Subject: Oyster Creek Nuclear Generating Station
Docket No. 50-219
SEP Topic III-5.B, Pipe Break
Outside Containment

JCP&L RESPONSES TO
NRC STAFF POSITIONS ON SEP TOPIC III-5.B
PIPE BREAKS OUTSIDE CONTAINMENT
OYSTER CREEK NUCLEAR PLANT

JCP&L RESPONSES TO
NRC REQUEST FOR ADDITIONAL INFORMATION
SEP TOPIC III-5.B, PIPE BREAK OUTSIDE CONTAINMENT
OYSTER CREEK

PLAN VIEW
EMERGENCY CONDENSER PIPING

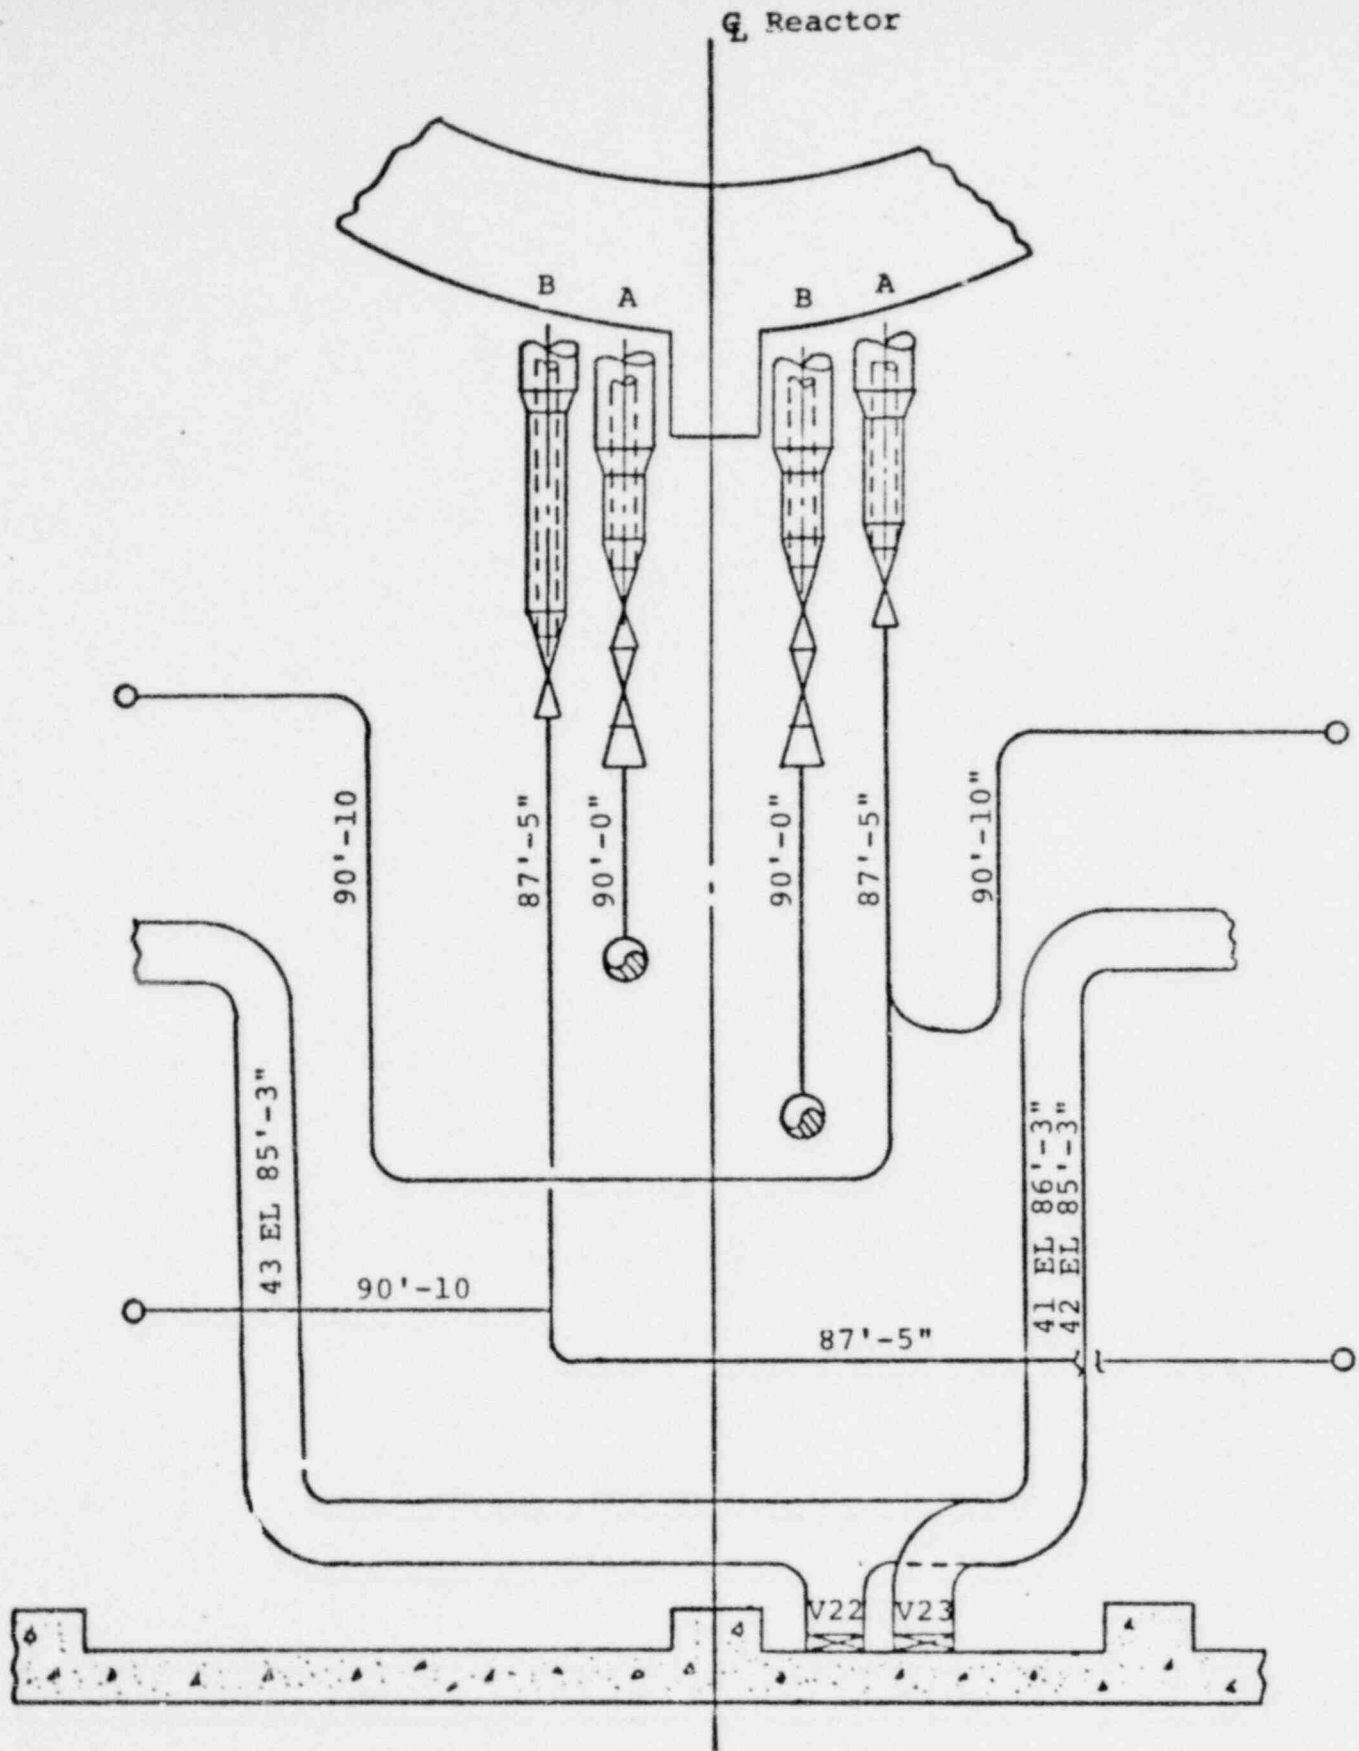
A plan view of the emergency condenser piping on the 75 foot elevation of the reactor building is shown in Figure 3. The effects of postulated HELBs in the emergency condenser piping are discussed in References 1 and 2. In essence, they conclude that protection from the effects of HELBs in the emergency condenser piping on the 75 foot elevation should be increased for the following reasons:

- ° Postulated pipe breaks in the steam supply and condensate return lines in the vicinity of the containment isolation valves could result in damage to both isolation valves, including power and control cables, on the steam supply line containing the break. Such damage could prevent the closing of these normally open valves on demand.
- ° Postulated pipe breaks at other locations in the condensate return lines could result in damage to Cable Trays V22, V23, 41, 42 and 43 and conduits containing power and control cables to both isolation valves on the steam supply lines containing the break, preventing their closure on demand.

JCP&L has evaluated possible plant modifications for mitigating the effects of HELBs in the emergency condenser piping on the 75 foot elevation of the reactor building. Based on our evaluation, we have concluded that the

following plant modification will provide increased protection for a) the isolation valves on the steam supply lines, and b) Cable Trays V22, V23, 41, 42 and 43 and conduits containing power and control cables to the isolation valves on the steam supply lines. The modification consists of installing a leak detection system on the emergency condenser piping as described below.

A leak detection system will be installed on the emergency condenser piping on the 75 foot elevation of the reactor building. The leak detection system will be capable of detecting and locating small leaks in the pipe before the break size becomes large enough to cause damage to the isolation valves, cable trays, and conduits due to jet impingement or pipe whip. This will allow plant operators sufficient time to take appropriate actions such as to visually inspect the area, isolate the line containing the leak, or shut down the plant.

PLAN VIEW
MAIN STEAM PIPING

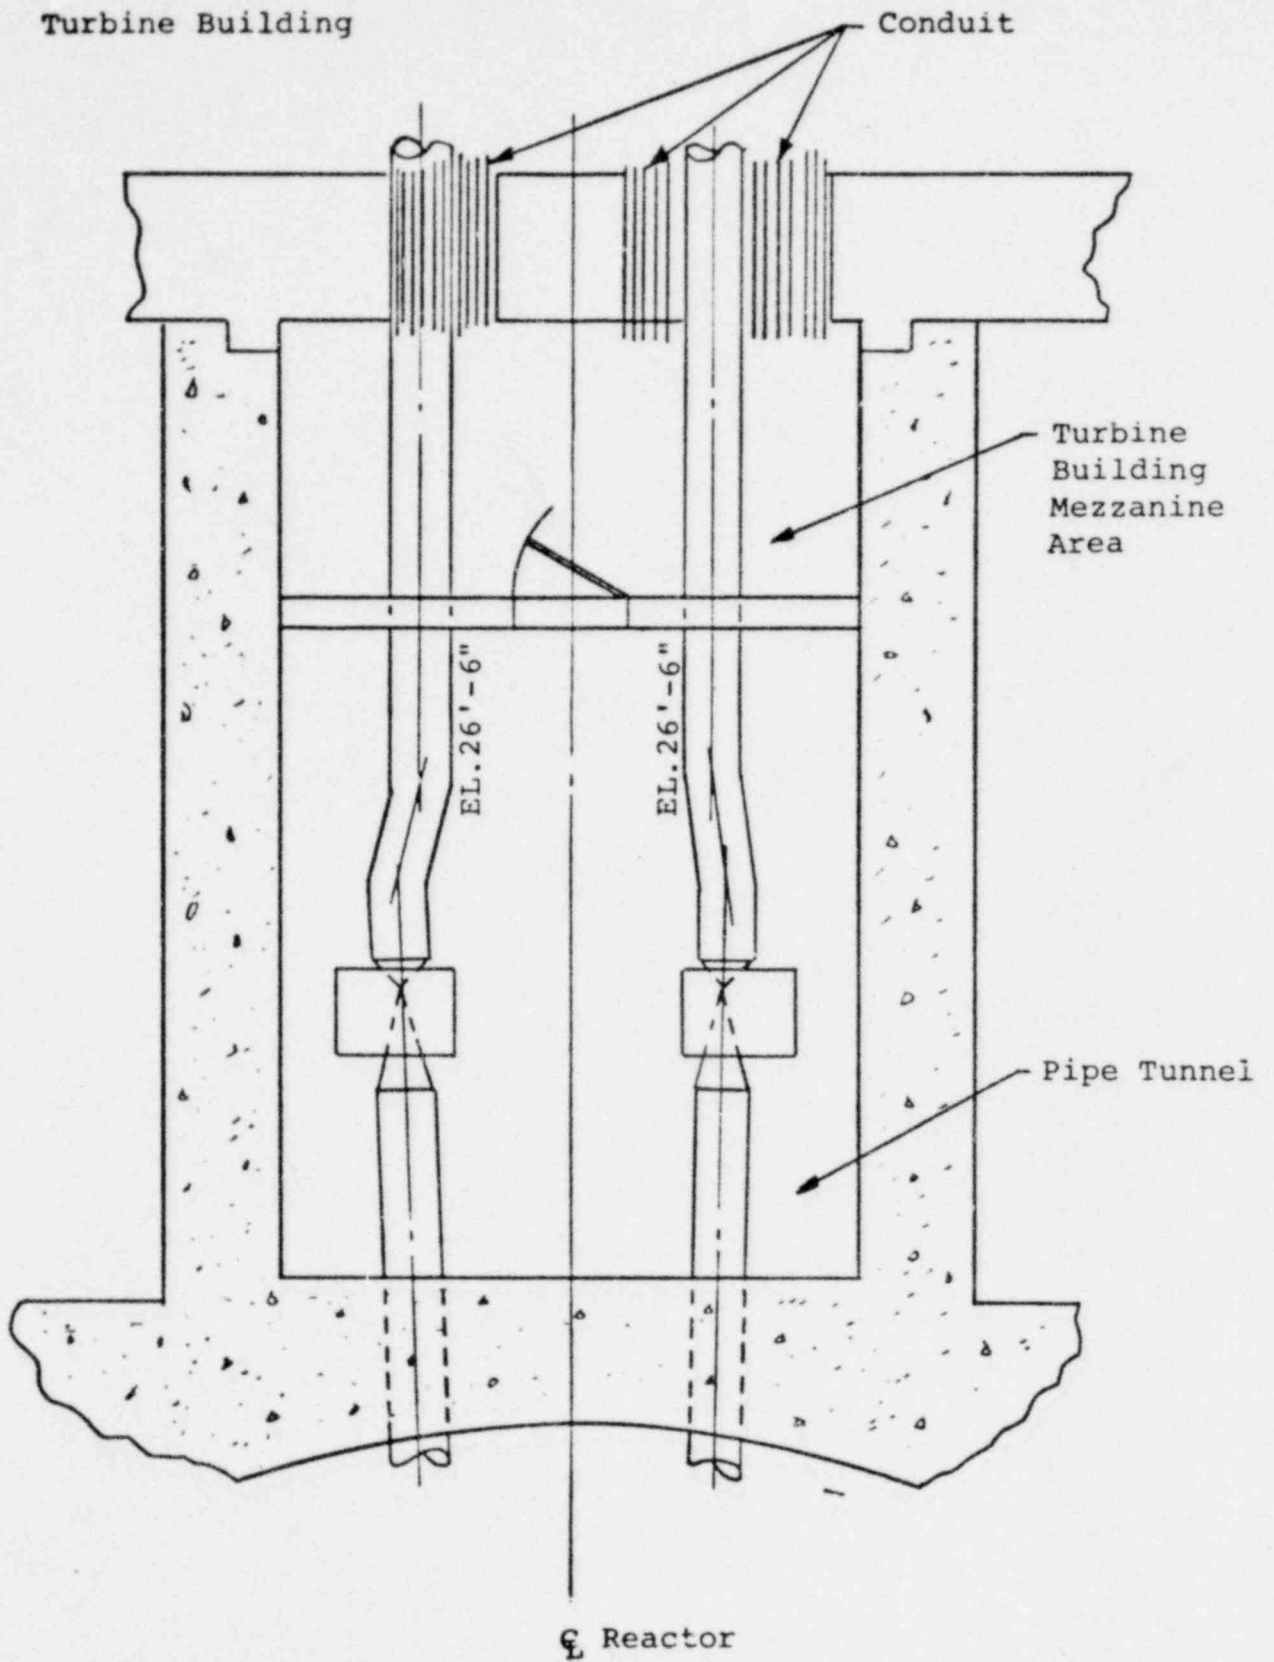
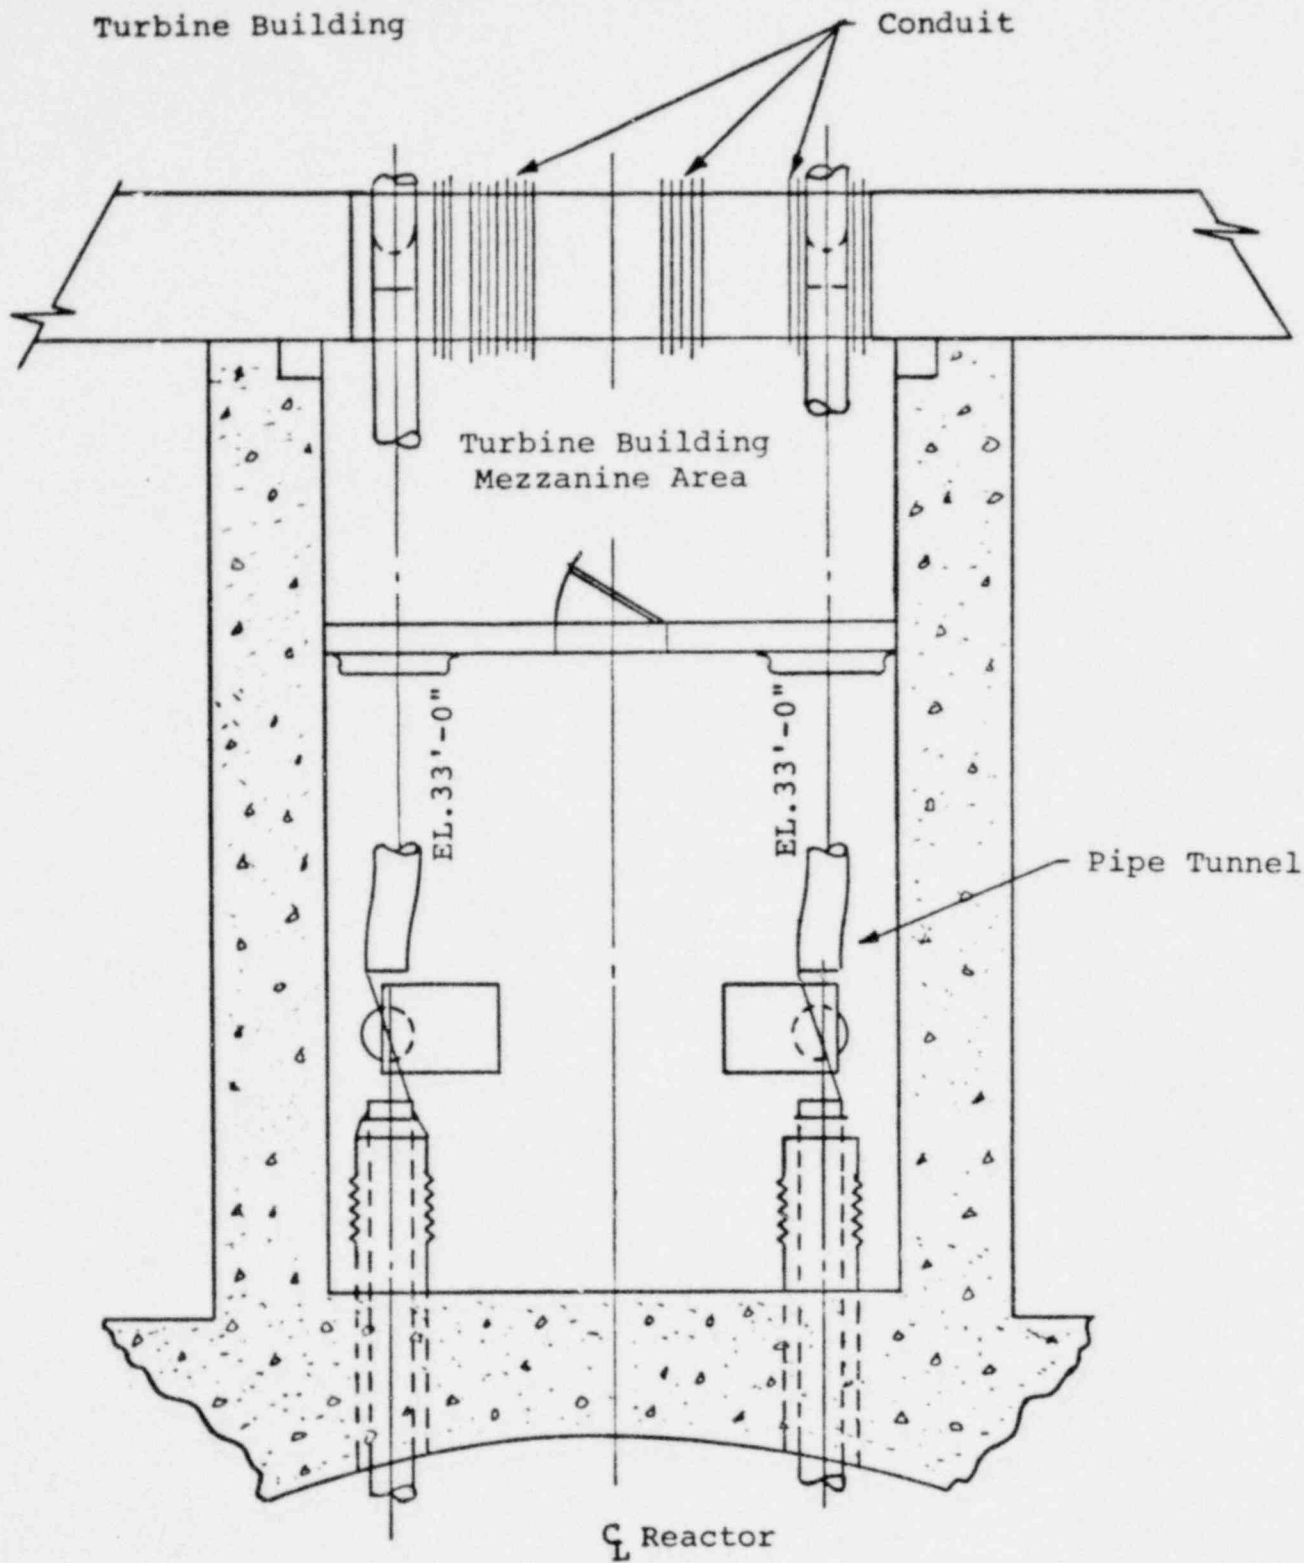
Plan views of the main steam and feedwater piping in the pipe tunnel and turbine building mezzanine area are shown in Figures 5 and 6, respectively. The effects of

postulated HELBs in the main steam and feedwater lines in the pipe tunnel and turbine building mezzanine area are discussed in Reference 3. In summary, HELBs in the main steam and feedwater piping in the pipe tunnel and turbine building mezzanine area could cause damage to the following electrical cables.^{1/}

- ° System II control cables for the emergency service water (ESW) system.
- ° System II control cables for the core spray (CS) system.
- ° System II control cables for the containment spray system.

Since a main steam or feedwater break would result in a turbine and reactor trip as a direct consequence of the break, a further loss of site-power together with a single active component failure must be assumed in accordance with NRC regulations. If the single active failure is assumed to occur in Diesel Generator #1, this would result in the

additional loss of function of System I of the ESW, CS, and containment spray systems. Thus, an HELB of the main steam or feedwater piping in the turbine building mezzanine area could result in the total loss of the ESW, CS, and containment spray systems.

The ESW system is used for long term cooling of the reactor core following a LOCA by cooling the containment spray system which cools the torus water which is circulated through the reactor by the CS system. For the above postulated HELB in which the ESW, CS, and containment spray systems are lost, long term cooling of the reactor core could be performed using the shutdown cooling system.

Thus the complete loss of the ESW, CS, and containment spray systems is considered acceptable from a safe shutdown standpoint. However, loss of the CS system would severely restrict the ability of the plant operators to keep the core covered with water during recovery from the postulated accident. For such an incident, water could be added to the reactor vessel by the control rod drive (CRD) hydraulic system. However, since the CRD hydraulic system was not designed as a safe shutdown system, no credit has been taken for it in safety analyses. Therefore, additional protection is desirable to assure the availability of at least one train of the CS system to supply water to the reactor coolant system for postulated HELBs in the main steam and feedwater systems in the pipe tunnel and turbine building mezzanine area.

The NRC evaluation is not correct with regard to CS availability for the above scenerio, in that each of the two redundant CS systems is completely single active failure proof. That is, each CS system contains sufficient power supplies, valves, pumps, etc., so that no single active failure would prevent the system from operating. For the above postulated HELB which included a) pipe break in main system or feedwater piping in the turbine building mezzanine area with subsequent damage to CS System II control cables as a direct consequence of the break, b) turbine and reactor trips with assumed loss of off-site power, and c) assume single active failure of Diesel Generator #1, the undamaged System I CS could be run from Diesel Generator #2. Therefore, at least one train of the CS system is available to supply water to the reactor coolant system. Accordingly, no plant modifications are required in the turbine building mezzanine area.
